Materials Reliability Program:
Electric Power Research Institute (EPRI) Review of
the Japanese Nuclear Operators' (JNOs') Aging
Management Plan for Prolonged Shutdown Periods
(MRP-435)

2018 TECHNICAL REPORT

Final Report, November 2018

Figure 4-1
Overall Summary of the JNO Report Approach and Conclusions

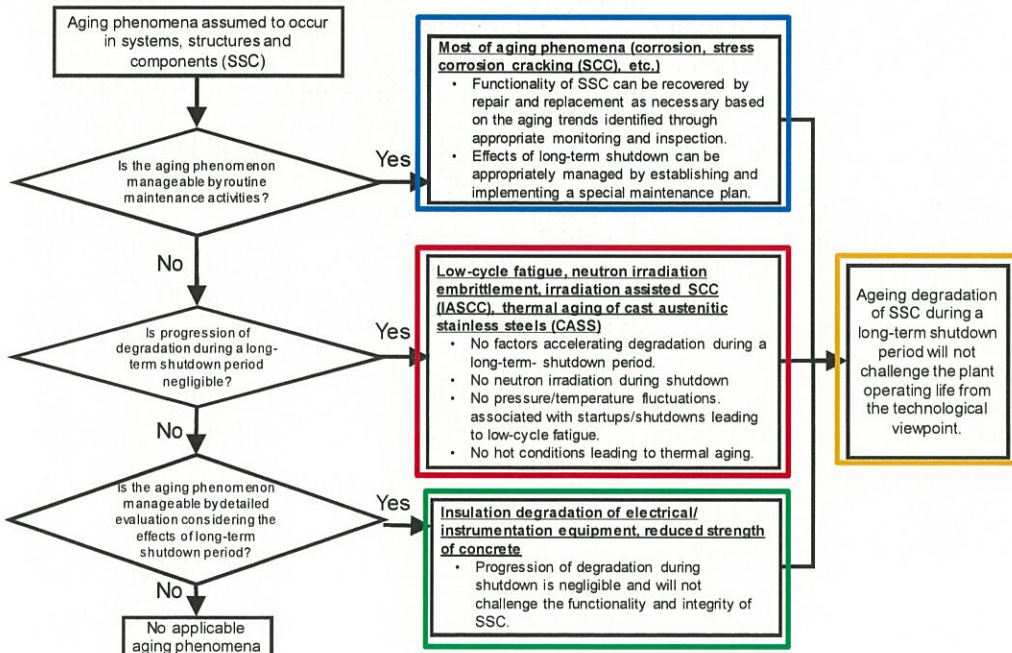
A summary of the overall technical approach of the JNO Report [4.1-1] and its conclusion are shown in Figure 4-1. As indicated in the red rectangle in Figure 4-1, the JNO Report identifies four specific aging phenomena that may be addressed by actions associated with aging management. Specifically, these four phenomena are:

EPRI reviewed the approach, logic, and associated conclusions in the JNO Report for these four specific degradation phenomena. EPRI's review of each of these specific areas and the associated conclusions that these phenomena will not progress significantly during long-term shutdown are detailed in the following subsections.

Figure 4-3
Example of the Environmental Effect Correction Factor (F_{en}) for Stainless Steels from (a) JSME's Environmental Fatigue Evaluation Method, and (b) NUREG/CR-6909, Revision 0

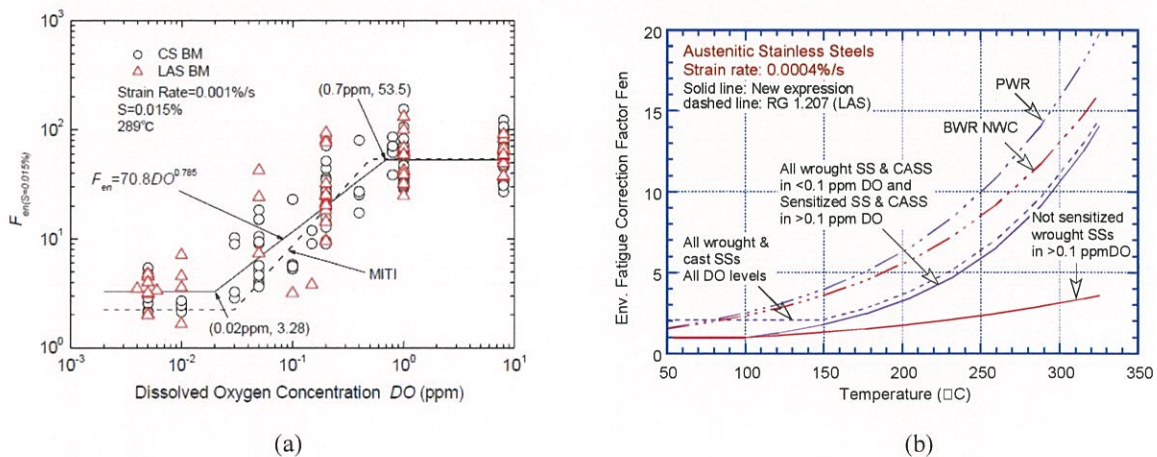
The JNO Report also discusses EAF, defined by the ratio N_{air}/N_{en} , representing the fatigue life in air, N_{air} , divided by the fatigue life in a water environment, N_{en} . This ratio is also called the environmental effect correction factor, F_{en} . Research efforts into environmental fatigue have been actively pursued in Japan and the U.S. and similar methods for evaluating environmental fatigue have been developed. The Japanese research and development results were incorporated into JSME's Environmental Fatigue Evaluation Method [4.1-5], whereas the U.S. methods used for LR are documented in NUREG/CR-6909, Revision 0 [4.1-6]. Example environmental effect correction factors from Figure 3.2.2.1 (1)-3 of the JNO Report are shown in Figure 4-3.

EPRI agrees with the JNO Report content regarding the factors that contribute to LCF. The factors are also consistent with the factors used in the U.S. for long-term plant operation, as identified in the fatigue aging management program description from the GALL Report cited in Section 4.1.1.

Figure 4-6
Transient Projection Methods

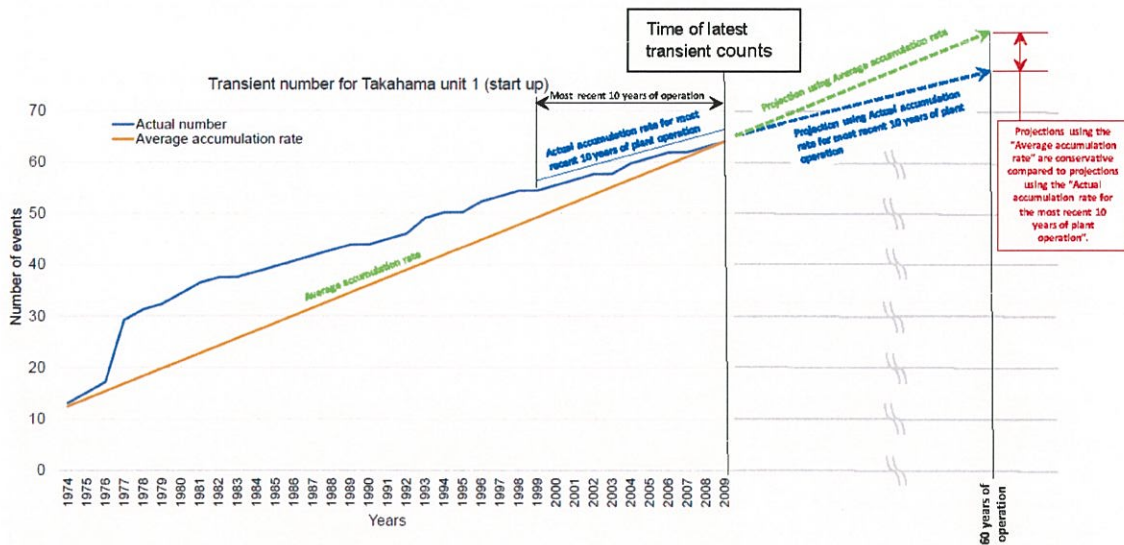
1. **Transient Projection Scheme:** EPRI determined that the method for projecting transients described in the JNO Report, which is the same as the methods in the Takahama evaluation, is conservative for two reasons. First, the future rate of transient accumulation considers the average rate of actual transient accumulation for all plant operation to-date. This is conservative because world-wide experience with nuclear plant operation indicates that transient accumulation rates are lower the longer plants operate. Generally, this is due to improved operating practices and modified fuel design and loading practices that allow longer operating cycles. A graphical illustration of this conservatism is shown in Figure 4-6, where different methods of projections for the Takahama Unit 1 Startup Event are shown. Use of the average rate of transient accumulation is conservative compared to a projection that is based on more recent plant operating practices. The second reason that the transient projection method is conservative is the application of an increased rate of transient accumulation for future operation. Figure 3.2.2.1(1)-8 of the JNO Report shows this increased rate (the slope of the “**Estimated transients**” line is steeper than the “**Past records**” line). Based on this information, EPRI concludes the transient projection scheme is appropriate and conservative for evaluating long-term operation.

Figure 4-7
 Comparison of Mihama Unit 3 and Takahama Unit 1 Startup Event 60 Year Projections to 3-Loop Westinghouse U.S. PWRs

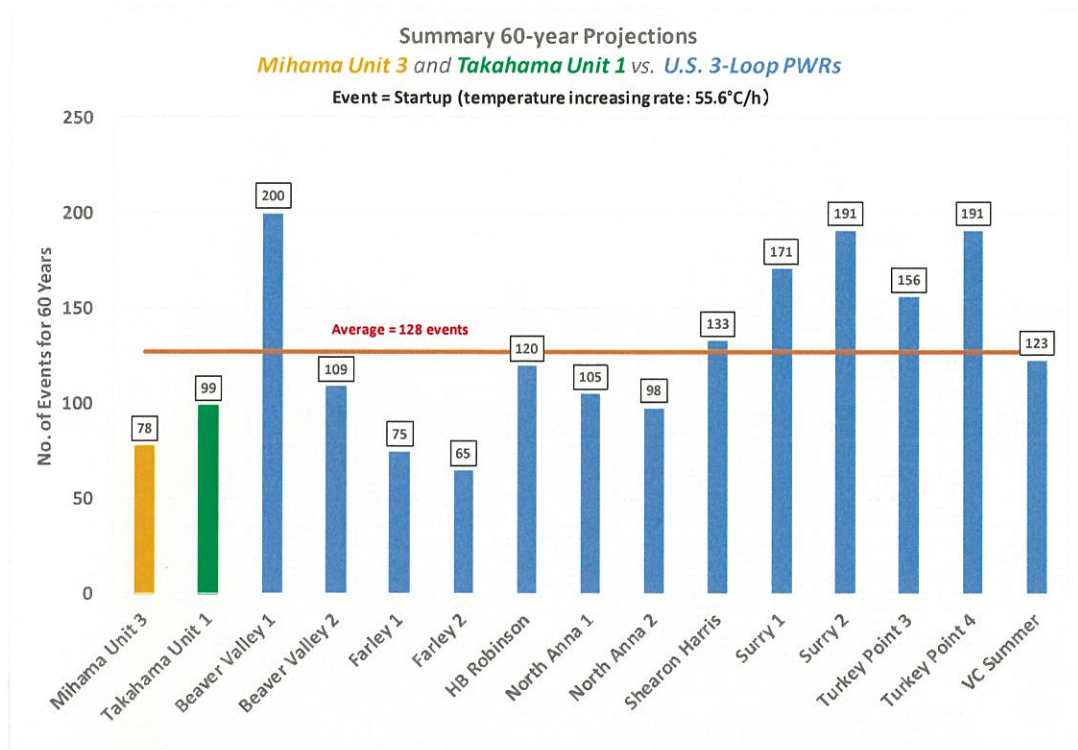
3. **Comparison of Transients to Similar U.S. PWRs:** To provide further insight into the transient selection and projection processes reported in the JNO Report, EPRI compared transient types and projections for 13 similar U.S. PWRs for 60 years of operation to the transient projections for Takahama Unit 1 in MRP-429 [4.1-7]. That comparison is shown in Table 5-3 of MRP-429. From that comparison study, EPRI concluded that the transient projections for Takahama are reasonable and slightly better than average vs. the U.S. PWRs. Table 3.2.2.1(1)-1 of the JNO Report provides similar projections of Operating Mode I transients for Mihama Unit 3. The Startup transient for Mihama Unit 3 is compared to the Takahama Unit 1 and U.S. PWR Startup transient projections from Table 5-3 of MRP-429 in Table 4-1 and Figure 4-7². For transient projections, plants in the U.S. have successfully used both of projection methods shown in Figure 4-6. The U.S. PWRs tend to use the “Average Accumulation Rate” which is less conservative than what the JNOs used for

Therefore, EPRI concludes the JNO Report approach to LCF evaluation for actual units is valid, and that the JNO Report approach to evaluate LCF in actual units is consistent with the approach used in the U.S. to manage fatigue for long-term plant operation.

Figure 4-8
Image of Calculation of Number of Transients for Evaluation

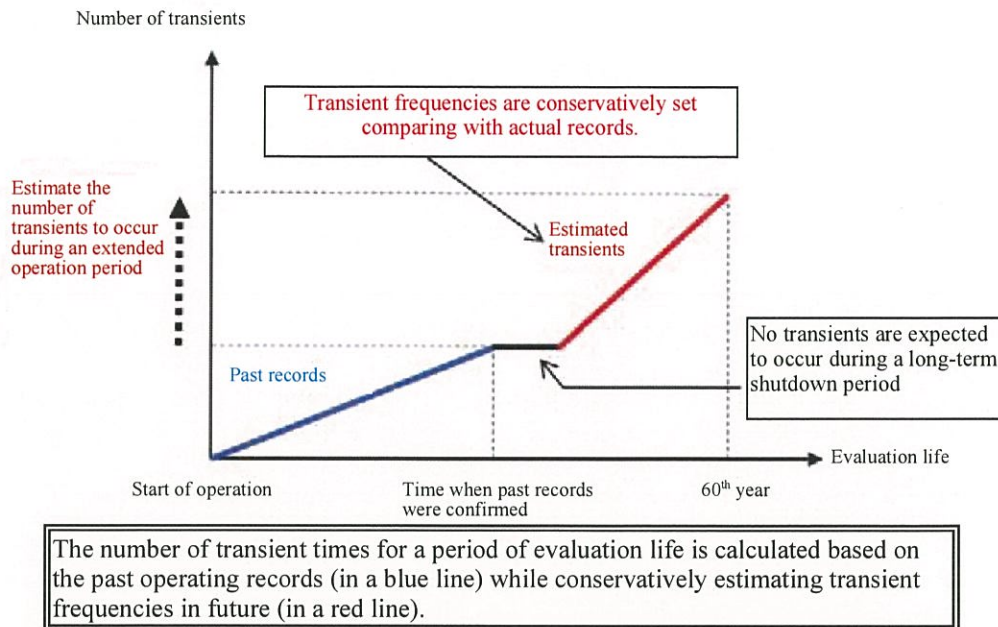
The JNO Report states that, in performing the LCF evaluation for individual RPV components, transient events such as those listed in Table 4-1 were considered. However, the JNO Report concludes that, "...since no transient events are expected to occur during long-term shutdown, plant long-term shutdown will cause no significant effects on LCF." Consideration of this effect on LCF is reflected in Figure 3.2.2.1(1)-8, which is duplicated in Figure 4-8.

EPRI agrees with the JNO Report conclusion that there are no significant LCF effects during long-term plant shutdown. EPRI's agreement is based on the fact that there are no significant transients during plant shutdown periods. LCF transients, such as those listed in Table 4-1 that are typical for 3-loop PWRs, are caused by changes in temperatures, pressures and flow rates. However, during plant shutdown:

Figure 4-9
Illustration of RPV Material Toughness and Neutron Irradiation Effects

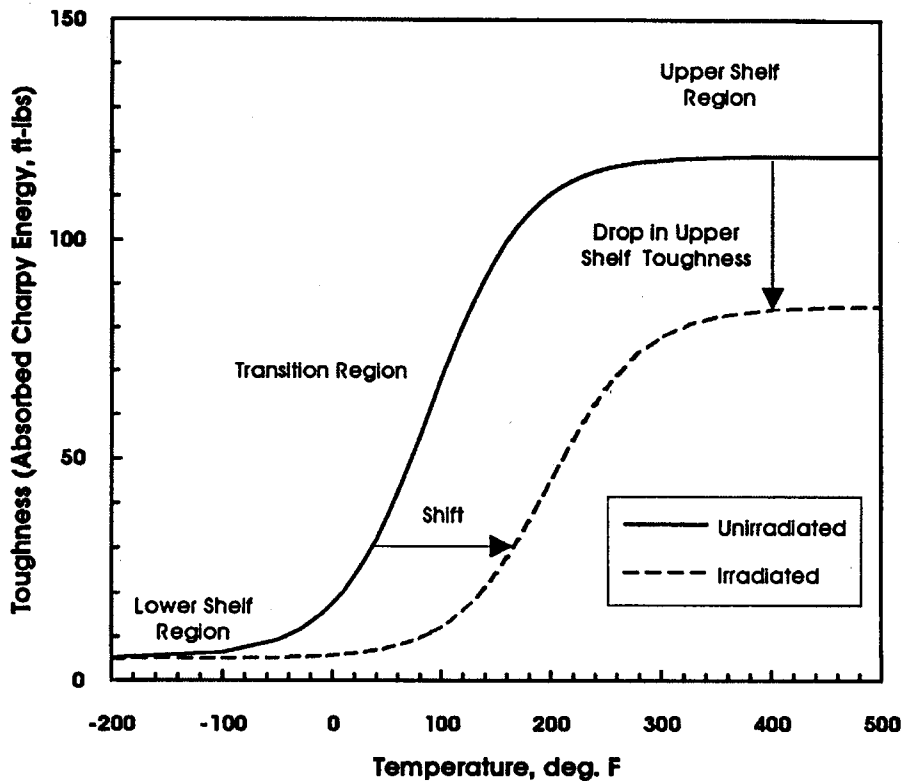
EPRI agrees with the fundamental premise of the JNO report regarding RPV integrity; the RPV is the most important pressure boundary component for light-water reactors (LWRs). Comments on low alloy steel neutron embrittlement, withdrawal and testing of RPV surveillance capsules, pressurized thermal shock (PTS), and USE reduction are included in the following subsections. EPRI also observed that a fourth aspect of RPV integrity, pressure-temperature (P-T) limit curves, is not included in the JNO Report. However, the JNO utilities have performed aging management using P-T limit curves and will continue to do so in accordance with Japan's regulatory requirements upon restarting operation. Additional comments and details on this aspect of RPV integrity are included in Subsection 4.2.5. Finally, EPRI recommends modifying the title of this subsection in the JNO Report by adding "...of the Reactor Pressure Vessel" since the entirety of this subsection is devoted to RPV integrity concerns and evaluations. This suggestion should minimize any confusion as to the intent of this portion of the JNO Report.
